Appliance Standards Awareness Project
American Council for an Energy-Efficient Economy
National Consumer Law Center, on behalf of its low-income clients

March 14, 2022

RE: Docket Number EERE–2019–BT–TP–0032/RIN 1904–AE77: Notice of Proposed Rulemaking for Test Procedure for Consumer Water Heaters and Residential-Duty Commercial Water Heaters

Figure 1. Daily flow and range of energy use for AO Smith Voltex 60-gallon HPWH⁸

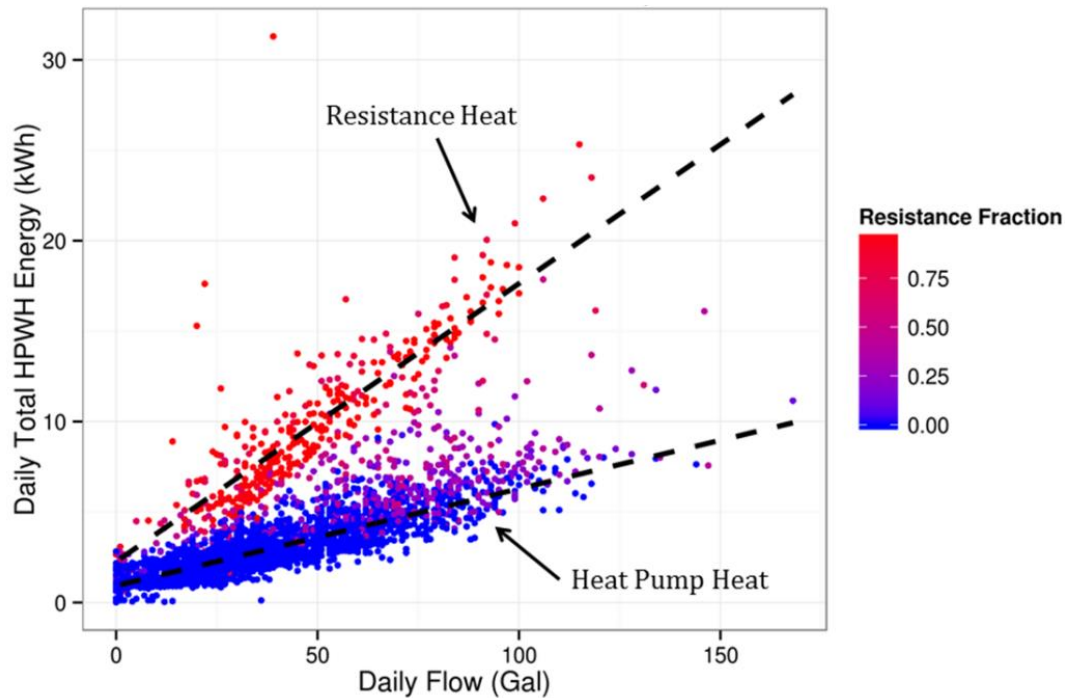
We encourage DOE to investigate the representativeness of the current draw pattern. HPWHs typically have auxiliary electric resistance elements to help increase hot water recovery and provide backup hot water in periods of high demand. In our comments on the RFI, we suggested modifying the test procedure to reflect the effectiveness of controls in minimizing the use of the electric element in HPWHs. According to the NOPR, DOE's test data shows that electric elements do not turn on during the 24-hour simulated-use test for most HPWHs.⁶ However, a 2015 HPWH study from the Northwest Energy Efficiency Alliance (NEEA) found that the average annual proportion of total input energy that was provided by resistance heat ranged from 4-45%, depending on the water heater model and location of installation.⁷ Figure 1, which shows the daily range of energy use for Voltex 60-gallon HPWHs, highlights the frequency at which the electric resistance elements were activated. Therefore, we encourage DOE to evaluate the current draw pattern and whether it is representative of the real-world operation of HPWHs.
